AGENDA FOR REGULAR MEETING VILLAGE OF TINLEY PARK PLAN COMMISSION

PLAN COMMISSION STAFF REPORT

The petitioner, Blake Purnell on behalf of C82 Commercial LLC, is seeking a Special Use for a Substantial Deviation from the Brookside Marketplace Planned Unit Development (PUD) and Site Plan approval to allow a 940 square foot building addition, façade changes, **a reduction of three parking spaces** and to permit a third drive-thru restaurant at 7228 W 191st Street in the B3 PD (General Business and Commercial, Brookside Marketplace PUD) Zoning District. The proposed Substantial Deviation and Site Plan changes would allow the previous Bank of America building to be expanded and converted to be a multi-tenant commercial building that includes a drive-thru Jimmy John's restaurant.

Above: Updated color landscape and site plan for January 3, 2018 meeting.

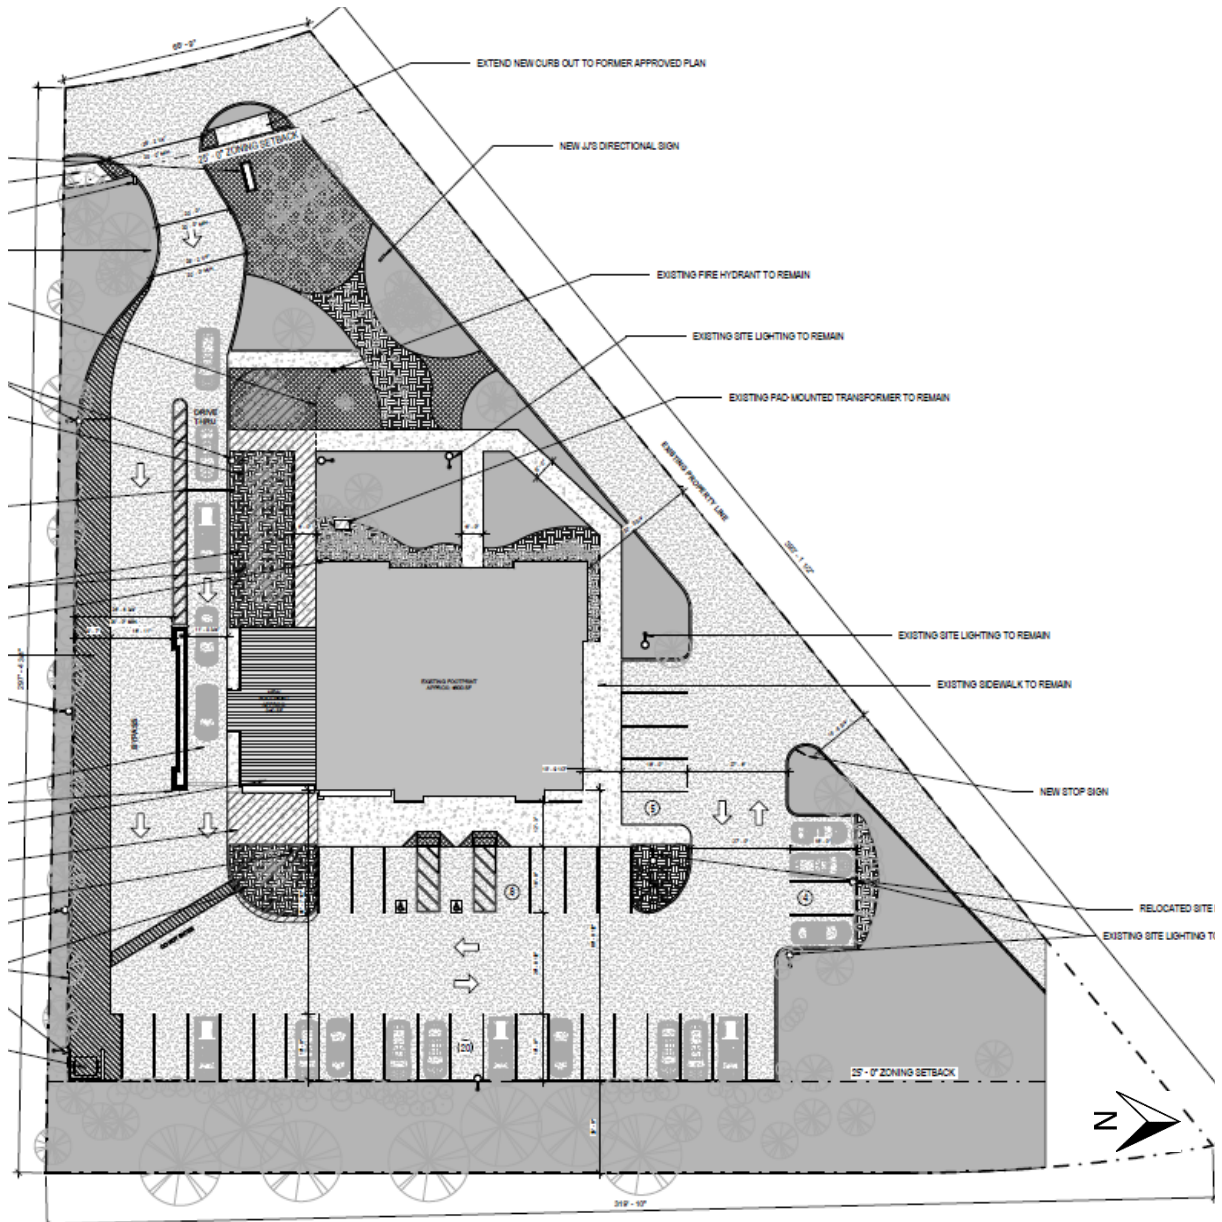
However, the width of the aisle is indicated at 26' 8.75" and is wide enough for two-way traffic. While it will be striped as one-way, it is still possible vehicles may go the wrong way down the aisle due to the extra width. A "do not enter" sign is proposed on the building by the exit to the drive-thru. A second "do not enter" sign should be placed to the south of the drive aisle to further reinforce that traffic should not exit the site that direction. A "no right turn" or "no exit" sign should be placed at the end of the parking lane for additional clarification as well. Additional consideration to reducing this drive-aisle width to between 15–18 feet should be considered. Dimensions of the entrances are not listed on the plans and will need to be indicated on the revised plans.

Concerns about site circulation and potential confusion and traffic conflicts were expressed. The revised plans completely remove one of the entrances on the west side of the property, adjust the entrance curb radius and realign the entrance drive aisle to be straighter. The removal of this entrance/exit also required the removal of three parking spaces. The area will have new curbing and landscaping installed in place of the pavement. The remaining entrance and the circulation around the building will remain one-way.

Five parallel parking spaces were originally going to be proposed along the south side drive aisle that was previously two-way. These parallel spaces would help make up for the lost parking in the rear of the building. However, due to fire code clearance requirements, the drive aisle is required to be a minimum of 20 feet and the parallel spaces could not be accomplished within the existing site layout. "Do Not Enter" and "No Exit" signs in addition to striping have been added to help clarify the one-way site circulation around the south side of the building.

Open Item #3: Revised plans are required prior to the Village Board meeting indicating a minimum entrance and drive aisle width of 20 feet around the site.

Above: Updated site plan for January 3, 2018 meeting. Plans will need to be revised prior to the Village Board meeting to remove note indicating the addition of five parallel parking spaces along the south side of the property.

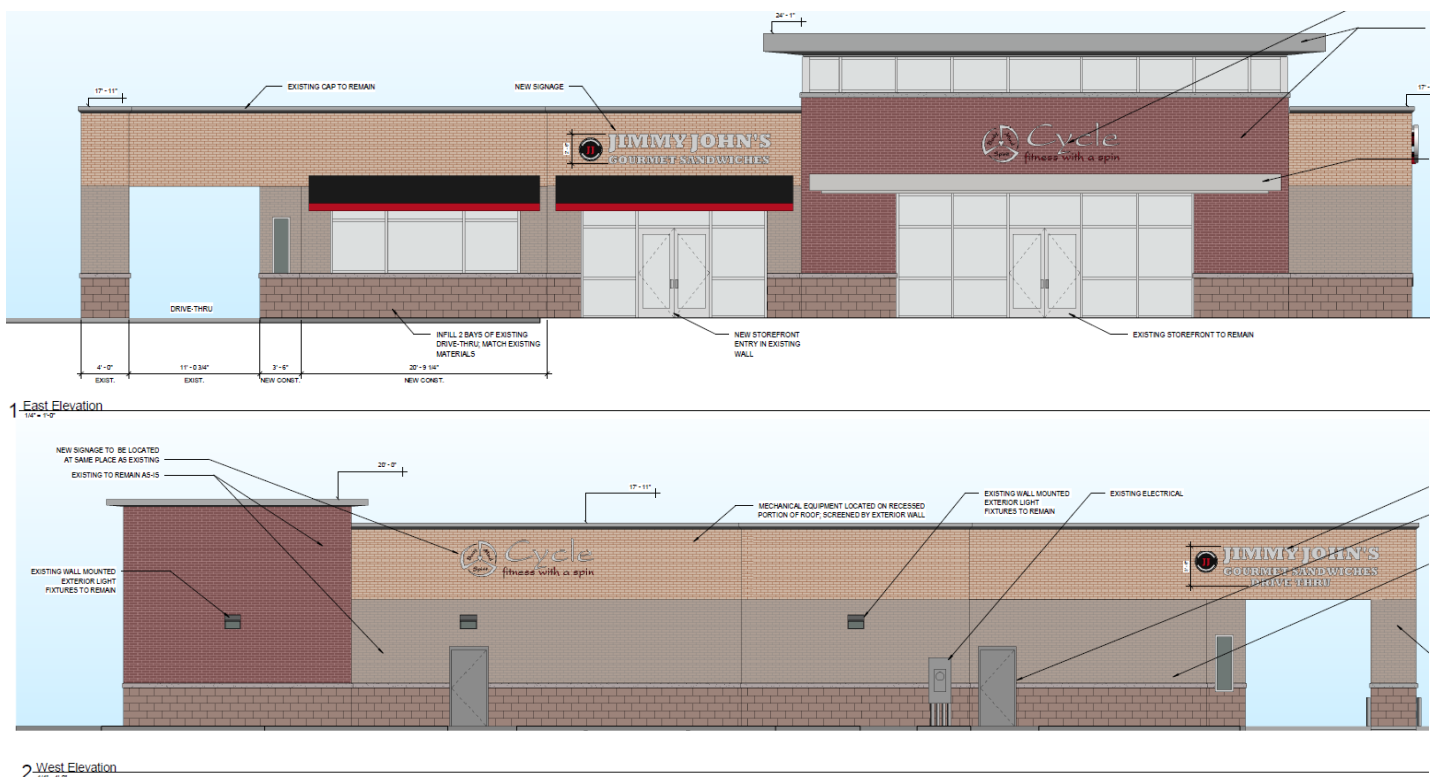
Landscaping will be maintained per the original 2006 landscape approval for Bank of America and any dead or missing landscaping from that plan will be replaced. Additional landscaping is being added where the landscape islands are being expanded and to better screen the “back of house” area that faces the interior ring road. The proposed landscaping will utilize the same species types that currently exist on the site and used elsewhere in the shopping center. The additional landscaping and curbing will help direct traffic through the site and create a more inviting site.

The ring road sidewalk will be completed to the drive aisle (currently ends at Taco Bell lot line). While this sidewalk does not connect to another interior sidewalk it will connect to the drive aisle and avoid the trip hazard created by the unfinished sidewalk. The sidewalk will allow a connection into the rest of the shopping center. Site lighting meets current lighting standards and will remain unchanged.

Additional landscaping was added where the second entrance was removed. The realigning of the entrance island's curb allows for the shopping center walkway to be continued all the way through the site.

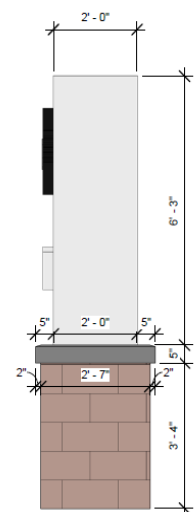
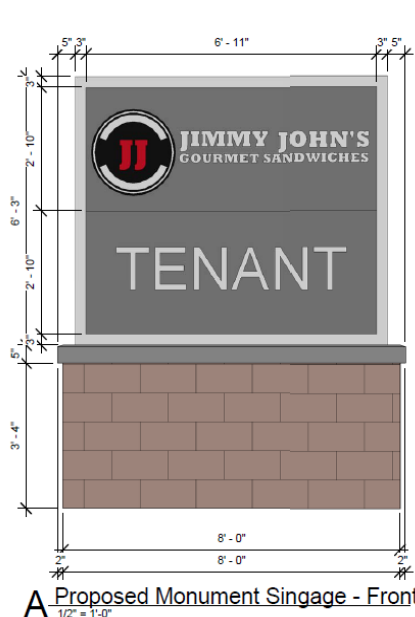
The petitioner submitted a revised ground sign (image on the right) with a brick base and cabinet. The design indicates raised lettering and logos. Flat tenant panels would be permitted, however, the two tenant panels would be required to have the same style. While simple in design, the ground sign is similar to the existing ground signs for the nearby Arby's, Taco Bell and TGI Fridays.

The Jimmy John's corporate sign information for wall and direction signs was submitted but was not site-specific and did not indicate which versions of the signs would be used. Additionally, no signage specifics were forwarded for the menu board. Additional information and review will be required for directional sign locations to ensure they are set far enough back from drive aisle and that they are necessary to provide direction and not just additional advertising signage. No signage variations or approvals are part of these requests and all signage will need to be in compliance with the PUD and Zoning Code signage requirements and will be reviewed at the time of permitting.

Open Item #6: No signage has been approved with this project and separate permits shall be submitted for review in compliance with the PUD's sign requirements.
